PRICE RIVER COAL COMPANY

Re: Proposed Drainage Control Modifications
Hardscrabble Canyon, Carbon County, Utah

The following responses are submitted to address the comments contained in Mr. D. Wayne Hedberg's letter of February 19, 1986 pertaining to the proposed drainage control modifications at our facilities in Hardscrabble Canyon near Helper.

FIGURE 3.3-8(A)
(REVISED - 3-11-86)

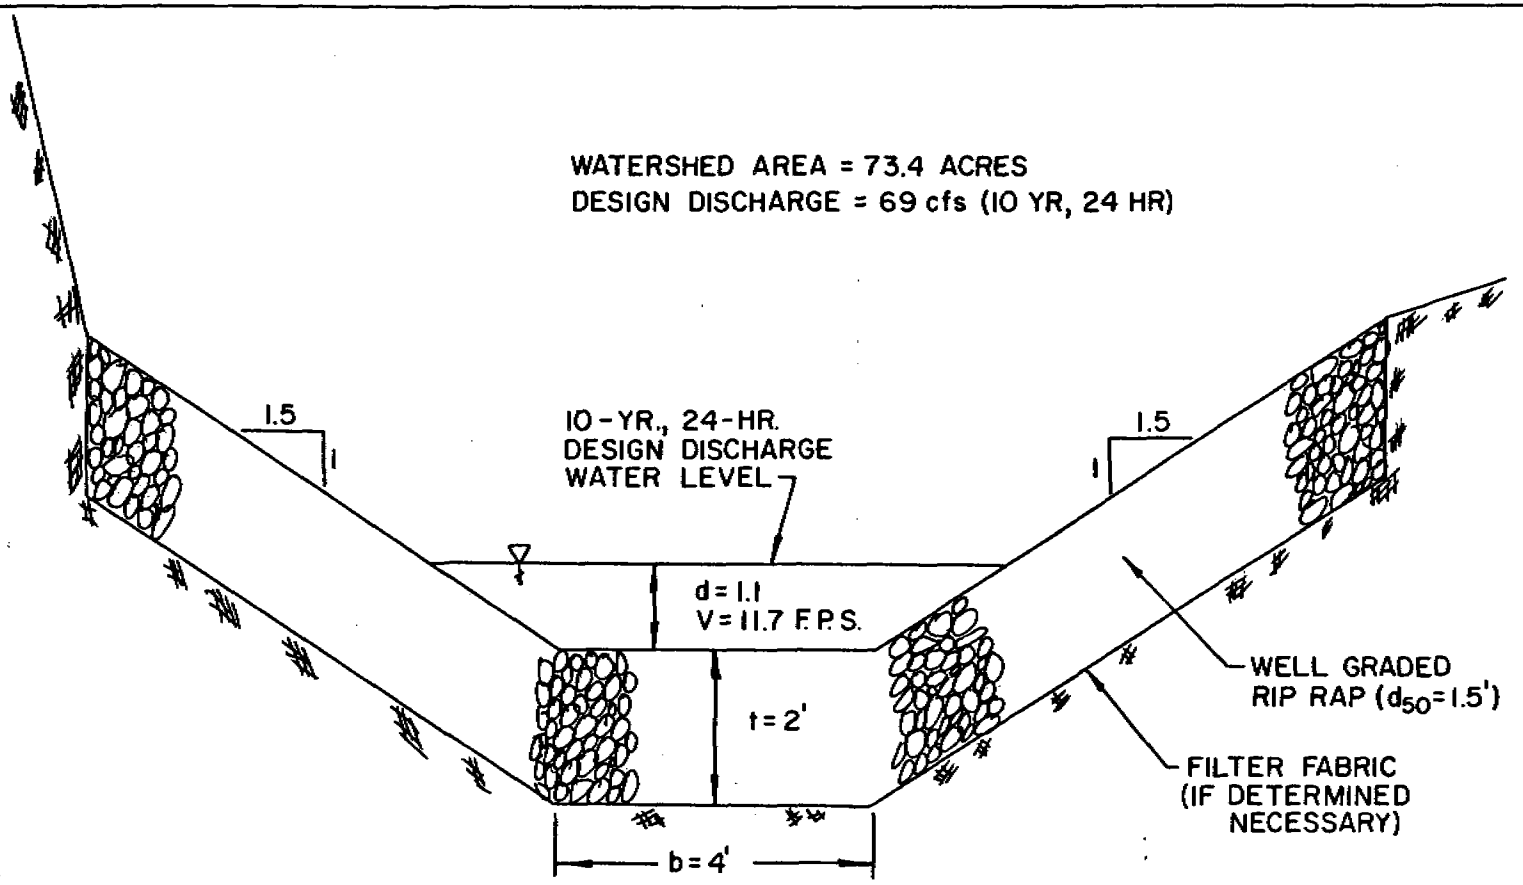
COMMENT 4: Comment #9 made by the Division in the December 30, 1985 deficiency letter required designs to demonstrate that each proposed channel will be stable at the design flows. The applicant must submit channel lining designs for diversions D-2, D-3, D-3A, D-5 and D-6. A Mannings "n" value that is representative of the riprap size to be used must be used for velocity computations. All figures of diversion cross-sections must be drawn to scale and revised to incorporate channel lining designs. Additionally, the applicant must commit to placing rip rap on all sections of diversion D-6 that are not excavated in bedrock.

COMMENT 6: Section 3.3-3(1)B states that diversion D-2 was constructed in rock. An on site visit performed by the Division on January 15, 1986 indicated that diversion D-2 is not constructed in rock but rather a valley fill material. The slope of diversion D-2, as determined from Exhibit 3.3-4a is 26% rather than the 10% which was used on Table 3.3-5(A). The design of diversion D-2 must be modified to reflect the unstable nature of the material, the correct slope, and a Manning's "n" value that corresponds to the size of rip rap to be used as a channel lining.

Table 3.3-5(A) and Figure 3.3-8(A) have been revised to contain the requested information for diversion D-2 below the outlet of culvert C-3.

RESPONSE: As stated in the response to Comment 4 above, a channel lining design for D-2 is being submitted for the reach of channel downstream of the outlet from culvert C-3. Actual field survey data indicates that the slope of the D-2 channel below C-3 varies from 13% to 17%. The maximum slope of 17% was used in the channel lining design. A Manning's "n" value of 0.045 was used in the rating presented in Table 3.3-5(A). This resulted in a computed velocity of approximately 11.7 feet/second. Figure 7-9(A) indicates that 18-inch stone riprap will withstand that velocity. The "n" value computed using a D50 of 1.5 feet is 0.042 which was judged to be close enough to the assumed value for design purposes. As stated above, Table 3.3-5(A) and Figure 3.3-8(A) have been revised to contain the design information for the channel lining. Section 3.3-3(1)B has been revised to contain a description of the riprap lining.

FIGURE 3.3-9(A)
(REVISED - 3-11-86)

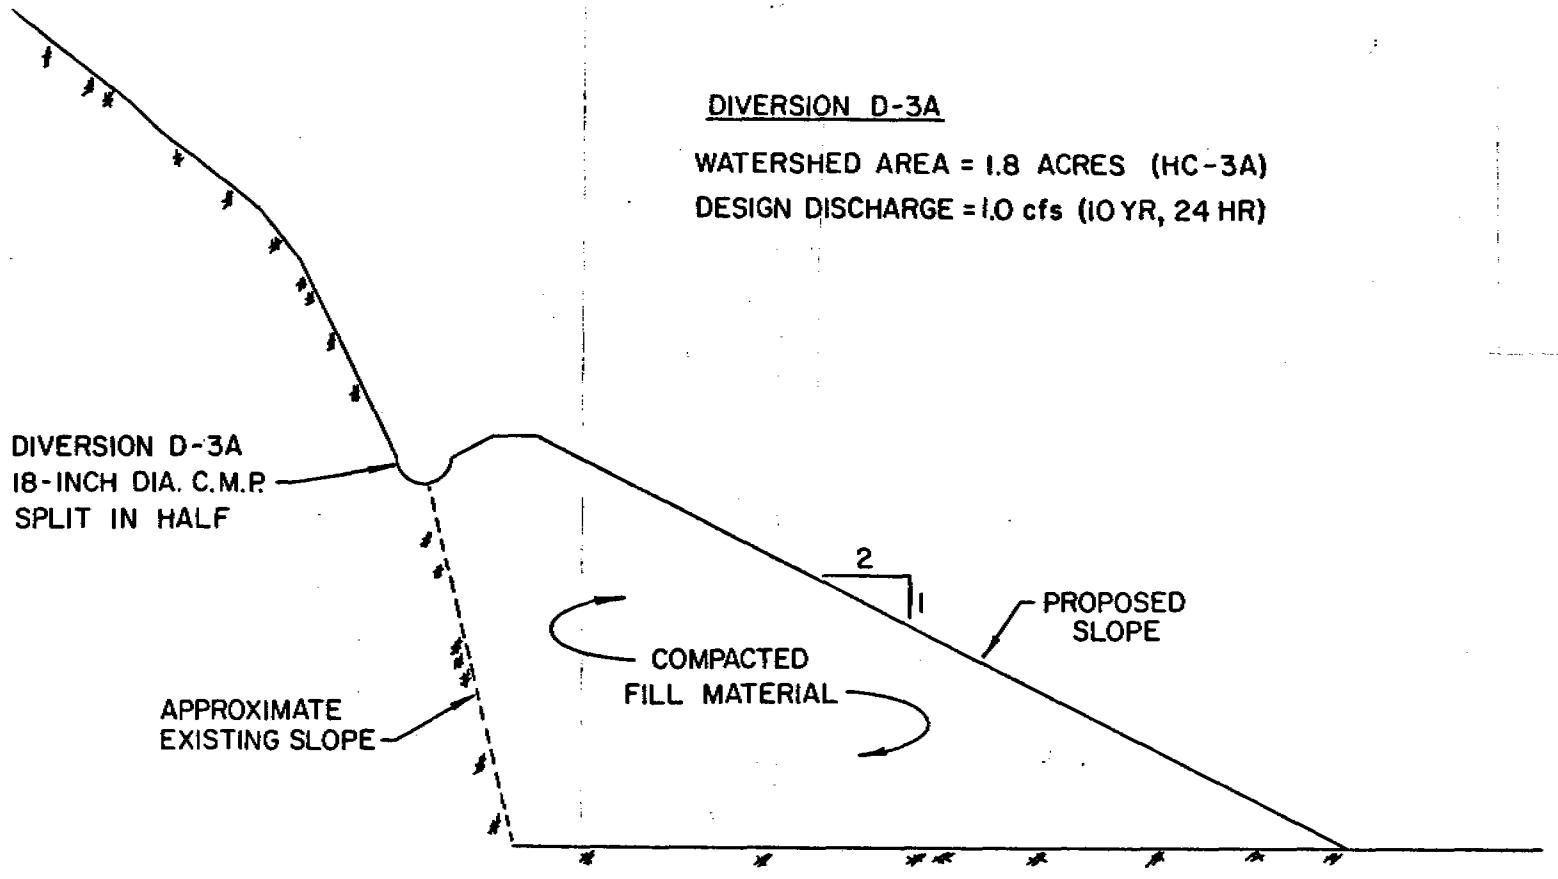
COMMENT 2: Comment #5 made by the Division in the December 30, 1985 deficiency letter required that the proposal must contain designs for the channel to replace culvert C-3. The applicant has stated that a small diversion, D-3A, will replace culvert C-3. The proposal states that the diversion will be excavated into rock. An on site visit performed by the Division on January 15, 1986 indicated that the location for diversion D-3A is not in rock but rather on an unstable slope. Therefore, complete designs for stabilizing the fill prior to the excavation of diversion D-3A are required. Additionally, Table 3.3-5(D) includes a Mannings "n" value of 0.045. Since the diversion will have to be excavated in stabilized fill a Mannings "n" value that is representative of a riprapped lined channel must be used to compute the velocity during the design event.

RESPONSE: Due to the unstable nature of the existing slope, it is proposed to stabilize the slope by placing additional fill against the slope. The outslope of the new fill will be sloped at 2H:1V. The proposed diversion D-3A will be constructed on top of the fill. Diversion D-3A will be lined with a half round culvert consisting of an 18-inch diameter CMP split in half. Figure 3.3-9(A) and Exhibit 3.3-10(A) have been revised to show the proposed modifications. Table 3.3-5(D) has been revised and contains a rating of the proposed diversion lined with the half round culvert.

The replacement of C-3 will also require the installation of a small diversion, D-3A, to convey the runoff from undisturbed area HC-3A to the main diversion. The location of proposed diversion D-3A is shown on Exhibit 3.3-4a. A typical cross-section of the proposed D-3A diversion channel is presented in Figure 3.3-9(A). Table 3.3-5(D) contains a HYDRO peak discharge determination for the contributing watershed, HC-3A, as well as a rating of the proposed ditch channel. Due to the unstable nature of the existing slope, it is proposed to stabilize the slope by placing additional fill against the slope. The outslope of the new fill will be placed at a 2H:1V slope. The proposed diversion D-3A will be constructed on top of the fill. Diversion D-3A will be lined with a half round culvert consisting of an 18-inch diameter CMP split in half. The discharge rating indicates that the design discharge will flow at a depth of about 0.25 feet and at a velocity of approximately 5.0 fps.

FIGURE 3.3-11(A)
(REVISED - 3-11-86)

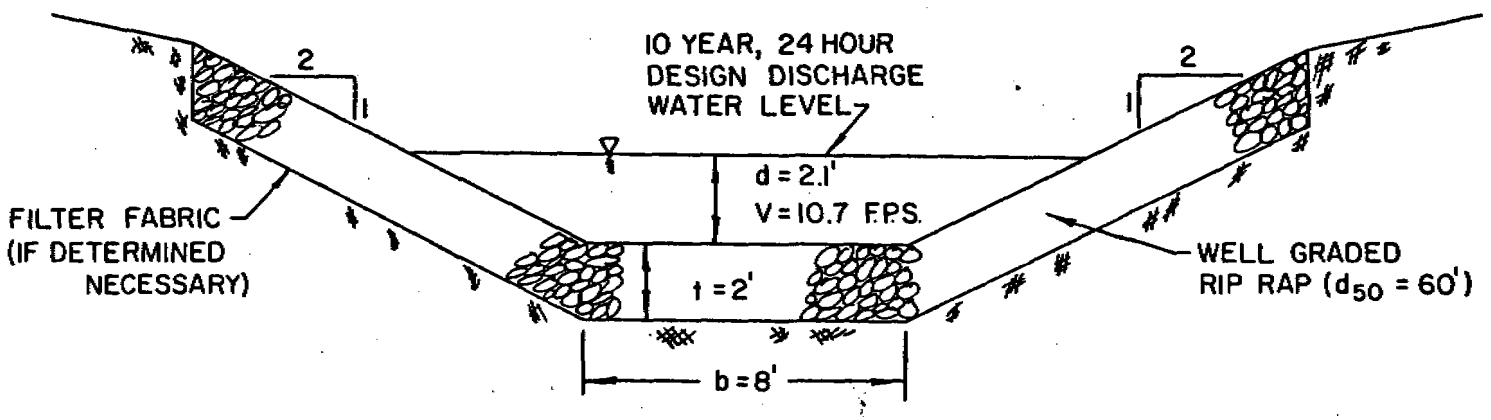
COMMENT 3: Comment #6 made by the Division in the December 30, 1985 deficiency letter requested channel stability measures for the reclaimed section of diversion D-5 in the vicinity of culvert C-2 after removal. Table 3.3-5(C) indicates that the design discharge will flow with a velocity of approximately 9.8 feet/second. Therefore, plans for a channel lining to minimize erosion at the design discharge must be submitted. Additionally, Table 3.3-5(C) includes a Mannings "n" value of 0.045. A Mannings "n" value that corresponds to the D50 rip rap size must be used for computation of velocity at the design event. Figure 3.3-11(A) must be revised to incorporate the channel lining design to be used.

RESPONSE: Due to the inter-relationship of Manning's "n", flow velocity and riprap size, the design of riprap linings is an iterative process. The process consists of computing a flow velocity based upon an assumed "n" value, determine the riprap size necessary to protect the channel at the computed flow velocity, calculate a new "n" value based on the riprap size selected, and if the new "n" value is appreciably different from the assumed value, recompute the velocity and riprap size. An empirical equation relating Manning's "n" and riprap size is presented in Applied Hydrology and Sedimentology of Disturbed Areas, Barfield, Warner and Haan, 1981. Equation 3.34 is n =0.0395xD50**0.1666, where D50 is the median riprap size. The above method and equation in conjunction with Figure 7-9(A), contained in the January 16, 1986 submittal, were used to design the riprap lining. Table 3.3-5(C) has been revised using an "n" value of 0.040. The computed flow velocity indicates a median riprap size of 1 foot is required. Figure 3.3-11(A) has been revised to show the proposed riprap lining. Section 3.3-3(1)B has been revised to reflect the above design modifications.

The removal of culvert C-2 discussed in Section 3.3-3(1)C will require reshaping the channel in the vicinity of the removed culvert. It is proposed to reshape the channel to conform to the existing stream channel geometry upstream and downstream of the culvert. Final reclamation of the channel is not proposed at this time since areas adjacant to the diversion channel will still be required for continuing operations in the area. Upon completion of mining activities in the area, final reclamation of the channel will be accomplished according to the reclamation plan in 3.3-4. Table 3.3-5(C) contains a rating of the proposed channel configuration after removal of culvert C-2. The rating indicates the design discharge of 270 cfs will flow at a depth of about 2.1 feet and a velocity of about 10.7 feet/second. Figure 7-9(A) indicates that 1 foot stone riprap can withstand the computed velocity. A typical cross-section of the proposed channel geometry and riprap lining is shown in Figure 3.3-11(A). Within 15 days prior to the placement of the riprap, PRCC will contact the UDOGM and after an on-site investigation and consultation with UDOGM the need for a filter blanket or filter fabric under the riprap will be determined.
